Burke-Gilman Trail Missing Link Project

Design Advisory Committee Meeting #4
July 27, 2017

Seattle
Department of
Transportation

Segment 1 – Input and Changes

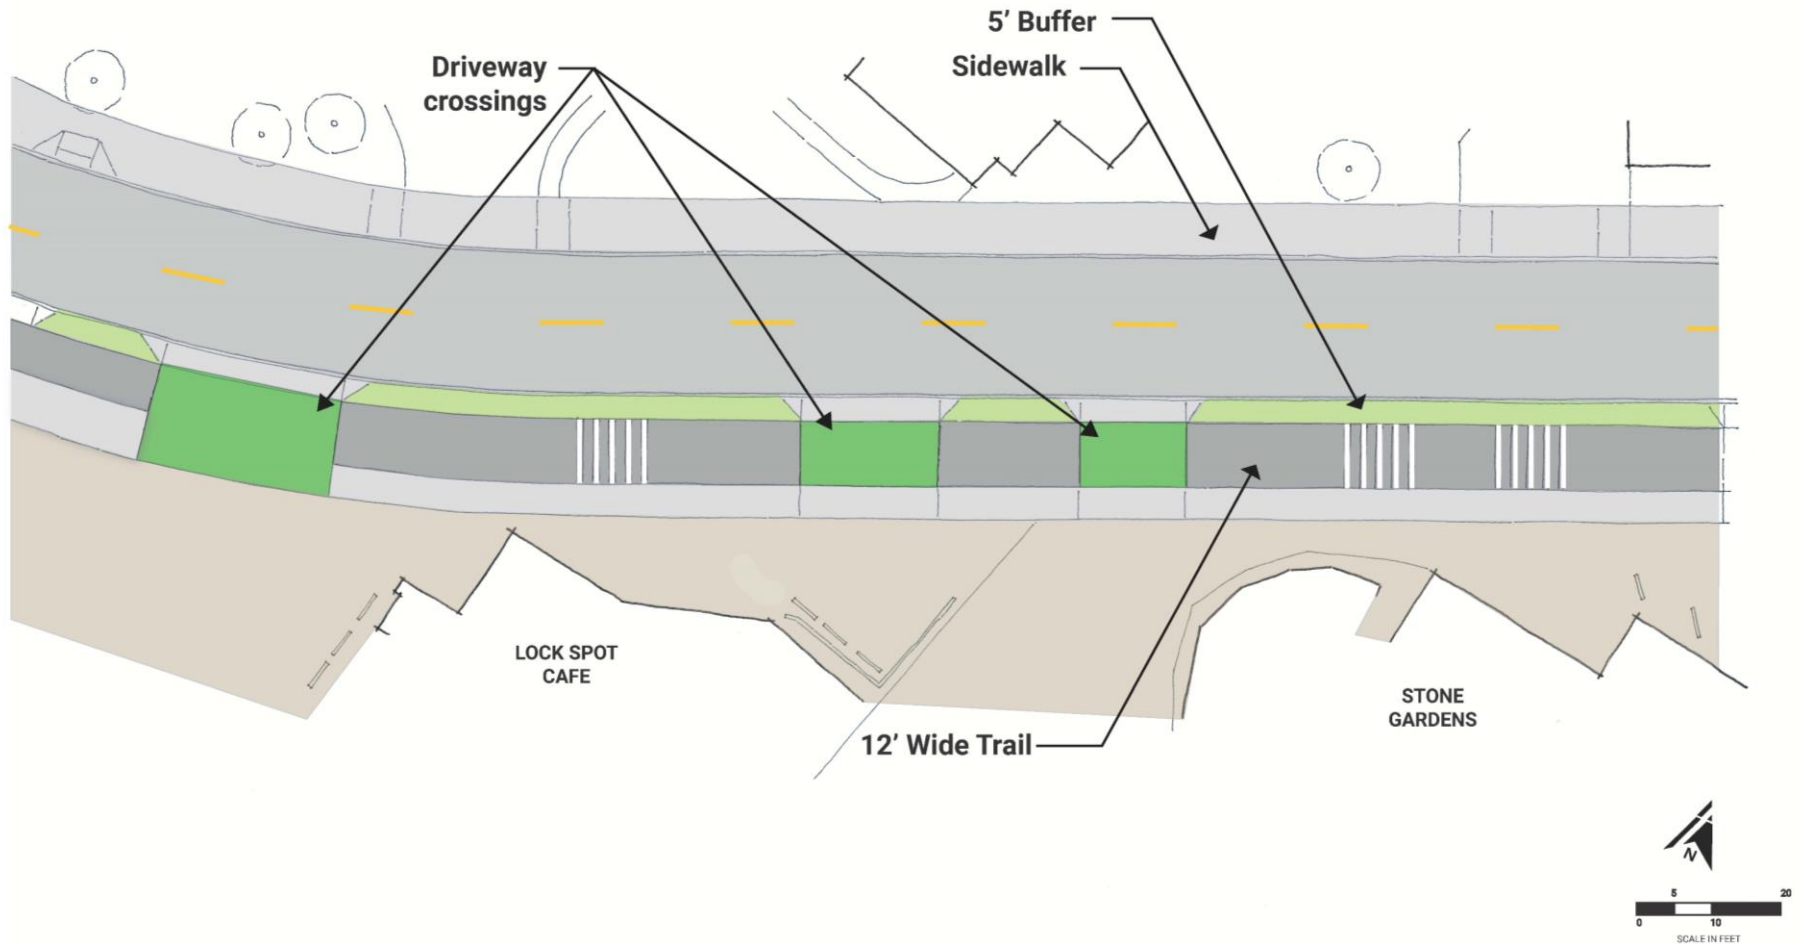
- **Maintain charter bus/metro layover parking spaces in front of the Locks**
 - This was shown as being removed in the FEIS design, but has been maintained in the 30% design.
- **Maintain 10' wide parking lane on north side of Market between 54th and 28th for Metro bus layover**
 - FEIS design had 8' parking lane, 30% design includes 10' parking lane.
- **Add westbound left turn lane at Market/28th with protected signal phase**
 - Included in 30% design
- **Coordinate design/construction with the Nordic Heritage Museum (NHM)**
 - Weekly meetings with the Nordic since June 2017, interim and final conditions included in the Nordic SIP and 30% BGT design
- **Use concrete instead of asphalt for Market St trail**
 - Included in 30% design, internal discussion ongoing

Segment 2 – Input and Changes

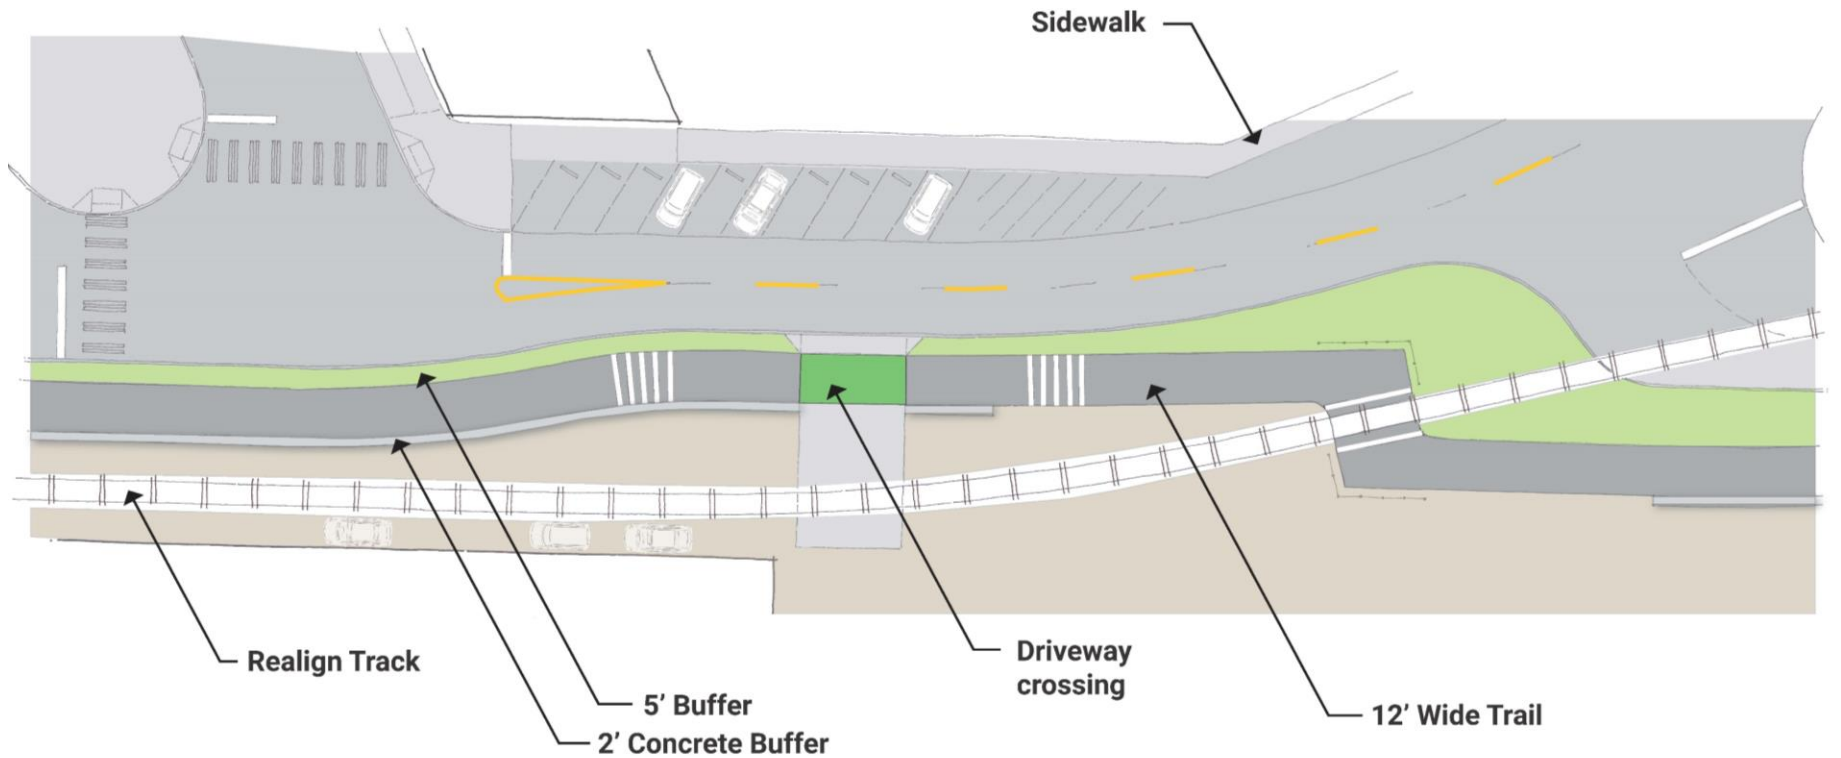
- **Improve safety at Shilshole/24th**
 - 30% design includes an option to close 24th and build a new roadway along the rail line (“54th extension”). Still studying WB67 movements or reroutes.
- **Improve rail crossing for bicyclists**
 - Added fencing and widened trail at the crossing
- **Maintain staging and parking space**
 - 20’ – 30’ of ROW will be unused and unregulated on the south side of Shilshole between approximately Vernon and 46th. This space can continue to be used for staging, loading, and/or parking.
- **Avoid drainage impacts to property owners**
 - Trail will drain toward the street and runoff will be captured in SPU managed storm drains.

Segment 3 – Input and Changes

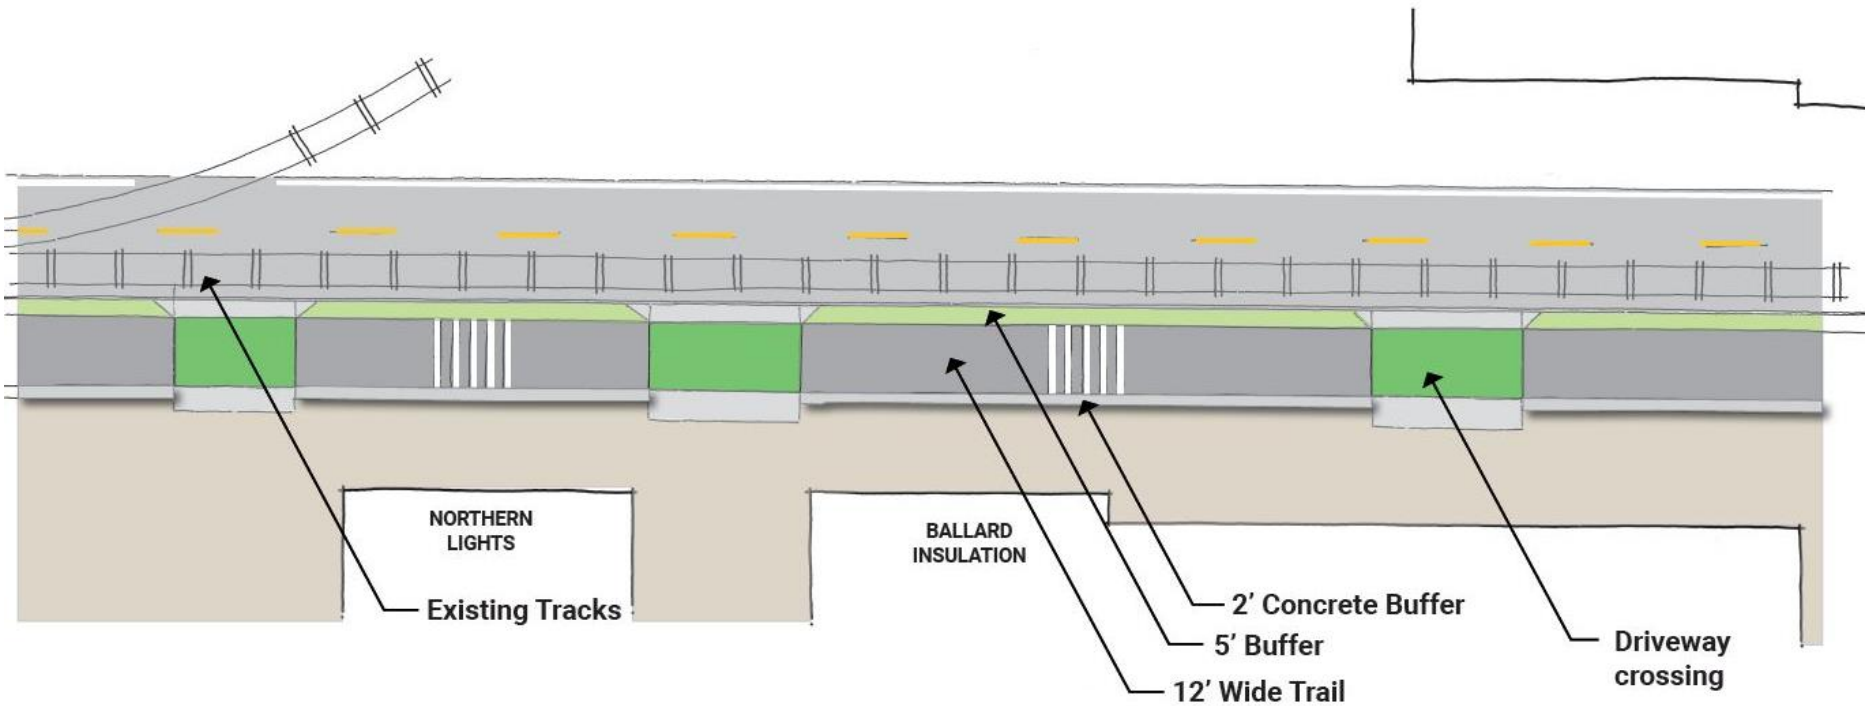
- **Increase lane width on 45th to 11 feet** to accommodate larger trucks
 - All lanes shown as 11 feet wide in the 30% design
- **Retain loading access for properties on the south side of NW 45th between 11th-14th**
 - Locking docks and access points are not impacted in 30% design. Route and movement of trucks entering / exiting loading dock to be discussed further during 60% design.
- **Maintain 4-way stop at 45th/11th**
 - Maintained in 30% design
